TECHNICAL NOTE

Job Name: BSIP Bus Rapid Transit (BRT), A33, Reading
Job No: 332110759
Note No: BRT-STN-HGN-RKLS-TN-CH-100001
Date: 28/07/022
Prepared By: Sachit Dahal
Subject: Rose Kiln Lane South Junction Geometric Compliance Review

Item	Subject
	 <i>Figure 1 RKLS junction proposed scheme</i>

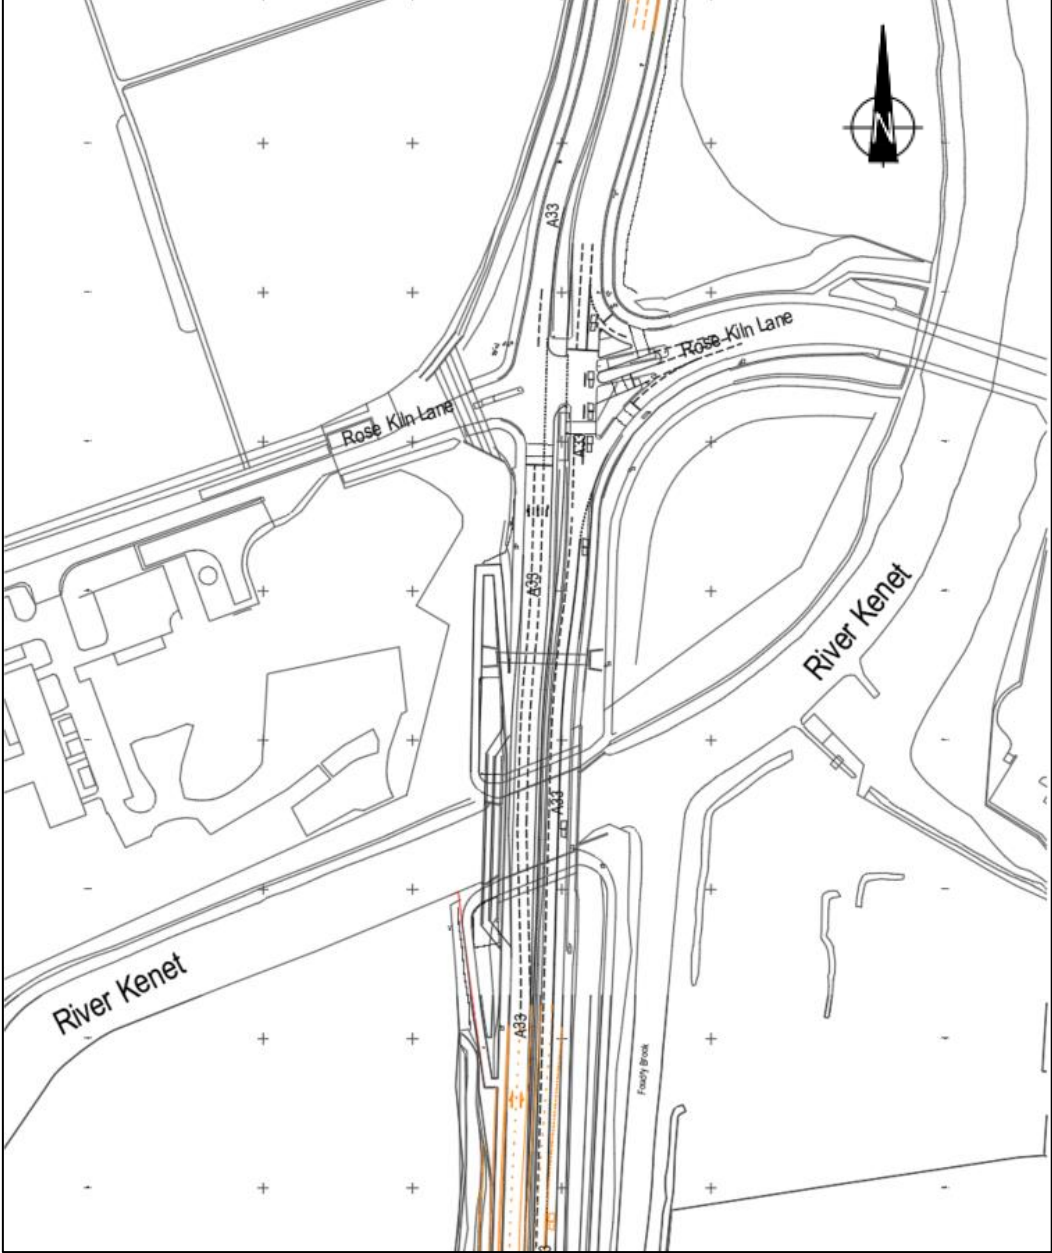
Item	Subject				
				<i>minimum SSD of the approach road.</i> On the approach from Rose Kiln Lane towards southbound on the A33 the signals are not visible from the SSD. It is proposed this vegetation should be cut back to remove this existing Departure.	
	B3	Design speed related parameters and relaxations	CD 109 cl 2.9	<i>Designs shall provide at least the desirable minimum values for stopping sight distance, horizontal curvature, vertical crest curvature and sag curvature as shown in Table 2.10, except for the following situations: 1) where a relaxation is permitted by sections 2, 3, 4 or 5 of this document; 2) the design of a vertical crest curve on a 2 lane single carriageway road (see Section 9).</i> The desirable minimum stopping sight distance is 120m on the A33 and 90m on Rose Kiln Lane. The stopping sight distance is compliant on the A33 however on Rose Kiln Lane going westbound the SSD is not compliant. Horizontal curvature 1020m, and K value of 30. To the north of the junction there is a horizontal curvature of around 140m.	Departure (existing)

B9	Design speed related parameters and relaxations	CD 109 cl 2.13	<i>The relaxations below desirable minimum in stopping sight distance, desirable minimum vertical curvature for crest curves and sag curves, described in Sections 3 and 5 of this document respectively, shall not be used on the immediate approaches to junctions</i>	Departure

Item	Subject				
				There is a relaxations at an immediate approach to the junction from Rose Kiln Lane to the A33 going Southbound.	
	B12	Stopping sight distance	CD 109 cl 3.2	<i>Desirable minimum stopping sight distance shall be available between any two points in the centre of each lane within the horizontal and vertical extents of the visibility envelope (measured for each carriageway in the case of dual carriageways and motorways).</i> The minimum SSD is available horizontally except at Rose Kiln Lane going southbound on the A33 and vertically as there is very little obstruction within the visibility splay.	Departure (existing)
	B25	Application of superelevation	CD 109 cl 4.9	<i>For improvements to existing roads without transitions, between half and two thirds of the superelevation shall be introduced on the approach straight with the remainder provided at the beginning of the curve</i> There is no superelevation applied to the north of the junction where there is significant horizontal curvature	Departure (existing)

B27	Widening on curves	CD 109 cl 4.11	<i>For carriageways less than the standard widths as defined in CD 127 [Ref 1.N], widening shall be: 1) 0.6 metres per lane where the radius is greater than 90 metres but below 150 metres subject to maximum carriageway widths of 7.9 metres, 11.9 metres and 15.8 metres (for 2, 3 and 4 lanes carriageways respectively); 2) 0.5 metres per lane where the radius is between</i>	Departure

Item	Subject				
				150 metres and 300 metres, subject to a maximum width not being greater than the standard lane widths in CD 127 [Ref 1.N]; 3) 0.3 metres per lane, where the radius is between 300 metres and 400 metres subject to a maximum width not greater than the standard lane widths in CD 127 [Ref 1.N]. The carriageway widths do not coincide with the figures shown on CD127, the lane widths are mostly less than required. 3.0m going northbound on the A33 and 3.25 going southbound on the A33, the bus lane is 3.2m wide. There is no widening on curves.	
	C3	Traffic lane width	CD 127 cl 2.2	Traffic lane widths for horizontal curvature greater than 400 metres radii shall be in accordance with Figures 2.1.1N1a to 2.1.1N1h. The carriageway widths do not coincide with the figures shown on CD127, the lane widths are mostly less than required. 3.0m going northbound on the A33 and 3.25 going southbound on the A33, the bus lane is 3.2m wide.	Departure

C5	Central reserves	CD 127 cl 2.9	Minimum central reserve widths shall be as shown in Figures 2.1.1N1a to Figure 2.1.1N1h except where the offside hard strip has been widened for drainage. Central reserve is proposed to be 1.2m wide for a long stretch of road	Departure
	C12	VRS set-back	CD 127 cl 2.24	The minimum dimensions for VRS set-back shall be as shown	Departure

Item	Subject				
				<i>in Table 2.24 and are illustrated in Figures 2.25a to 2.25d.</i> South of the junction the stretch of VRS cannot have a 600mm set back as the central reserve itself is 1.2m	
	C14	VRS set-back	CD 127 cl 2.26	<i>On central reserves where there are no obstructions and there is only one double sided deformable safety barrier between carriageways, the minimum set-back on both sides of the safety barrier shall be as stipulated in Table 2.24 but also no less than the working width of the safety barrier minus the actual width of the safety barrier.</i> VRS will be installed south of the junction. However, due to the narrowing of the central reserve the set back of the central reserve cannot be in accordance to this clause	Departure
